October 21<sup>st</sup>, 2024

**From:** Kevin Hansen, LHg., LG, LEED AP, County Hydrogeologist\

**Subject:** Hydro review of the proposed BAR Holdings UGA Swap, Land Use Amendment, and Rezoning

Figure 1 - Proposed BAR Holdings parcel groups discussed in the text 10/21/2024 kh

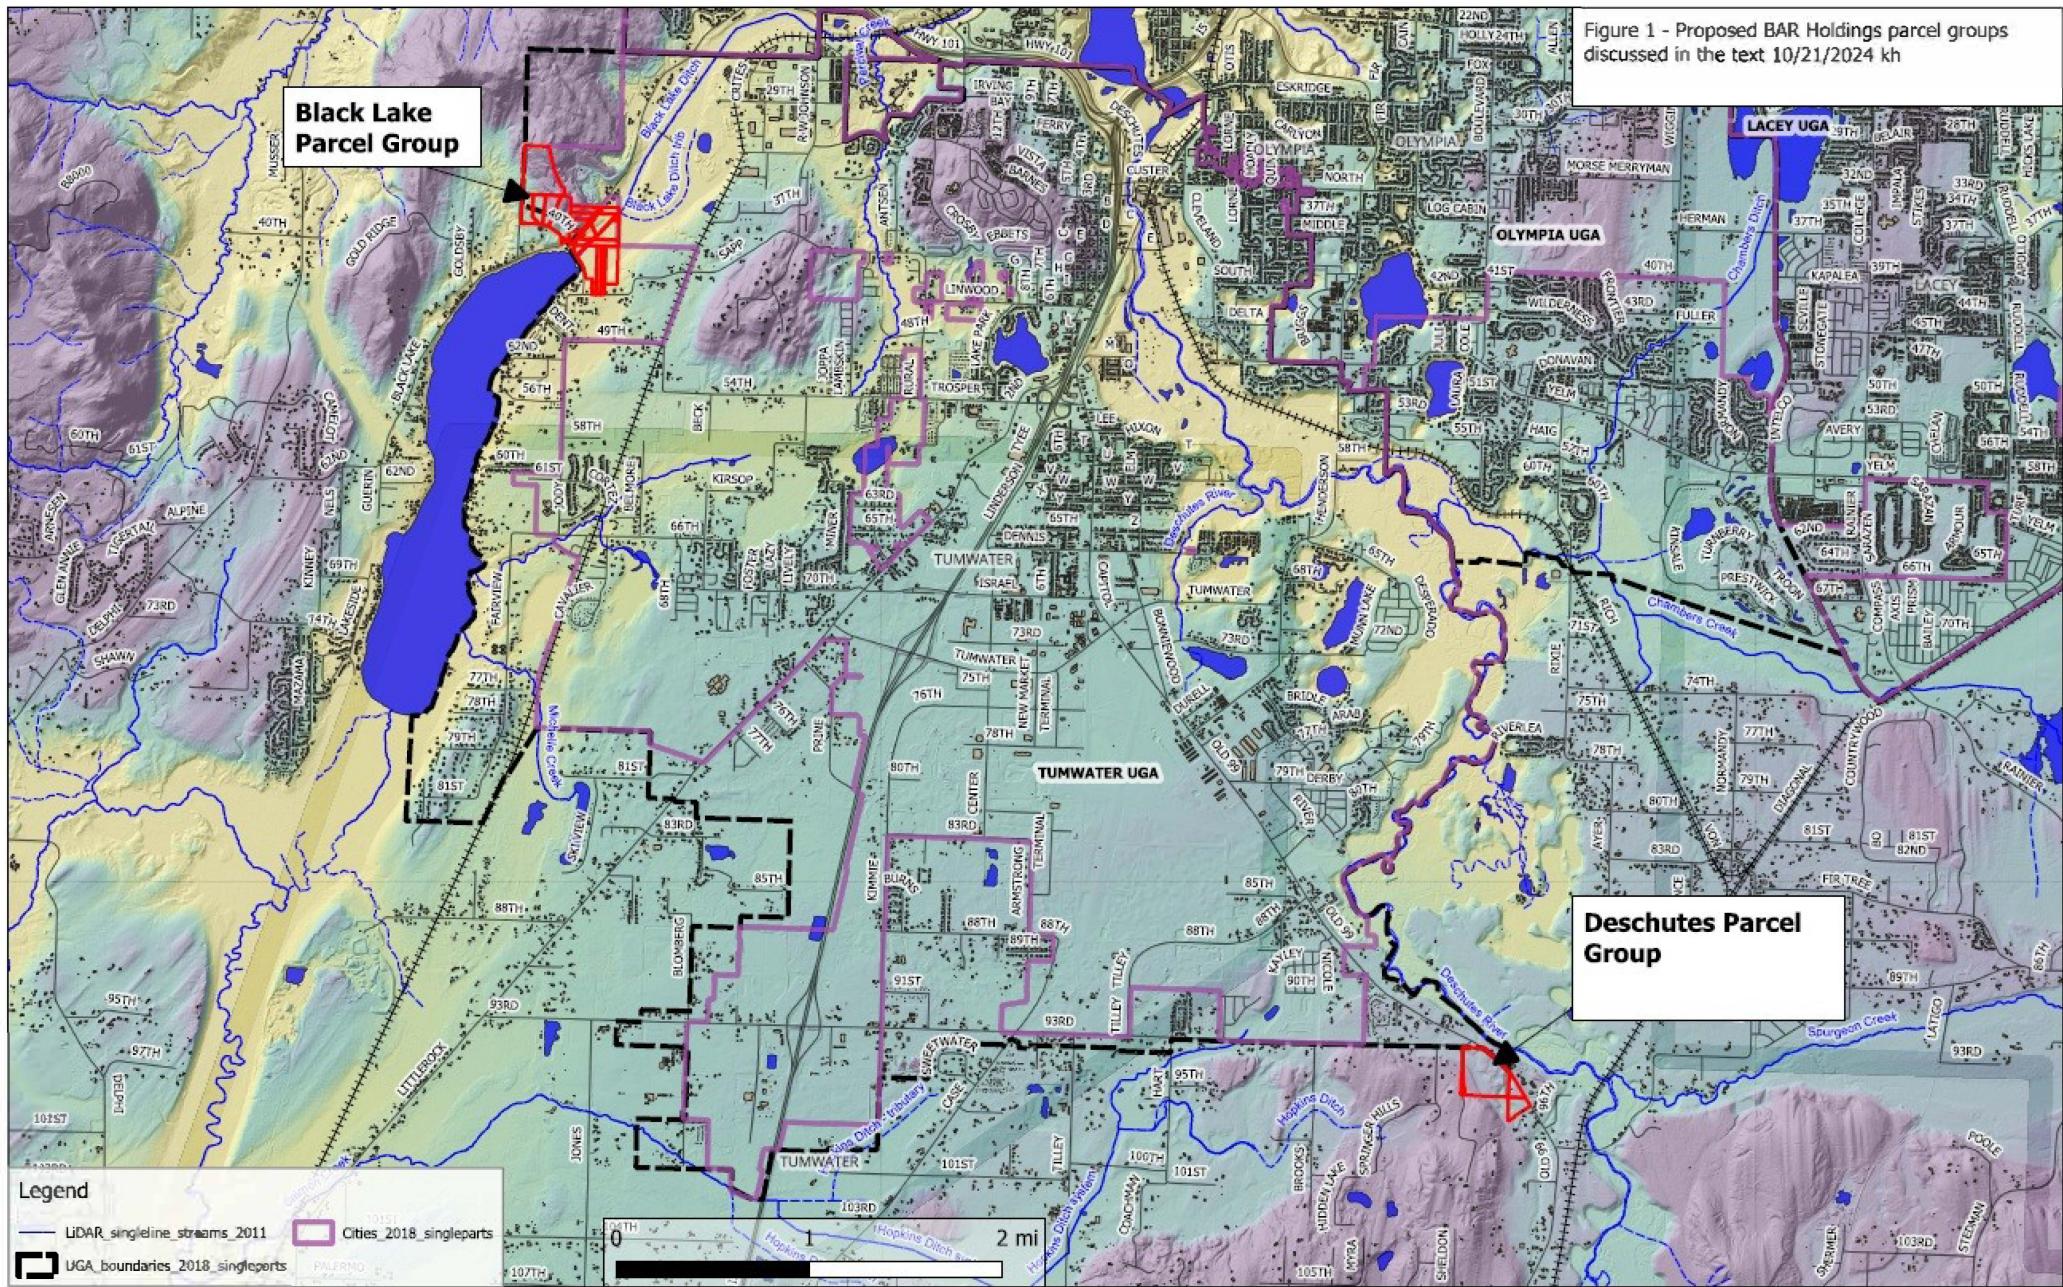
I have reviewed the major hydrologic elements of the proposed BAR Holdings proposal. The proposal is divided into two parcel groups as depicted on Figure 1, and the review is in two parts:

Also, documented groundwater quality problems northwest of these parcels on similar soils (Figure 1) – and likely associated with OSS/septic for wastewater management; I urge caution that septic design is inappropriate in this area.

Additionally, several important documented springs emerge nearby to feed baseflow in the Deschutes River (see Figure 1). Depending on the springs' capture areas, the flow to these springs has the potential to short-circuit (accelerate) the movement into the river any contaminants in stormwater, leaks, and spills.

Figure 2 - Deschutes parcel group - BAR Holdings proposed rezoning 10/21/2024 kh

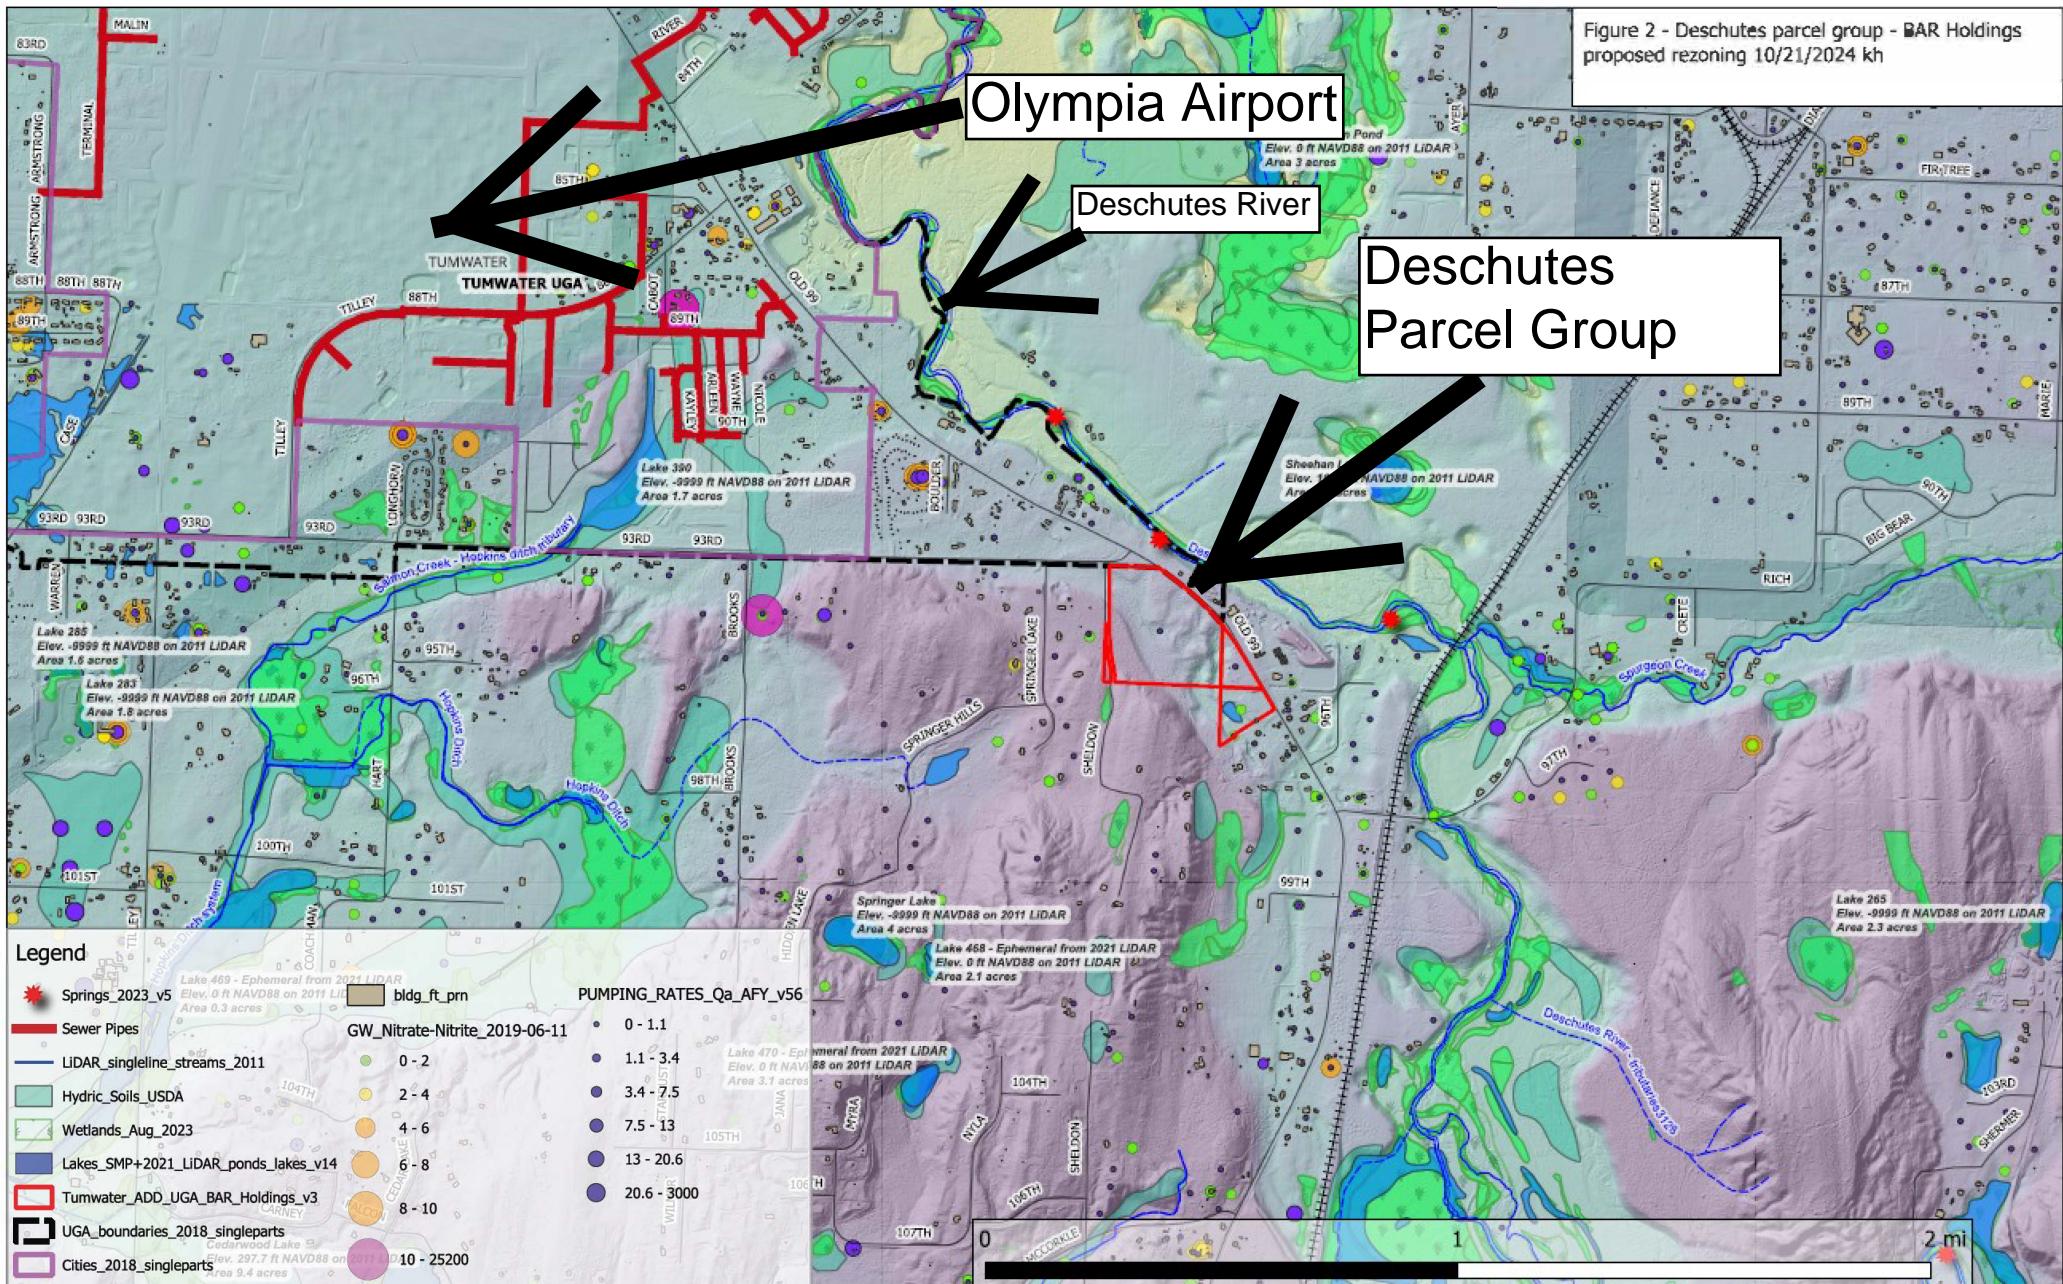
- Part 1: The part of the proposal adjacent to the Deschutes River (see Figure 2).
- Part 2: The part near Black Lake that involve a reduction in density (see Figure 3).

Note on Figure 2 that City of Tumwater sewer may be available within approximately one mile northwest of the proposed parcels, depending on a review of pipe/system capacity, waste strength, etc.

Additionally, several important documented springs emerge nearby to feed baseflow in the Deschutes River (see Figure 2). Depending on the springs' capture areas, the flow to these springs has the potential to short-circuit (accelerate) the movement into the river any contaminants in stormwater, leaks, and spills.
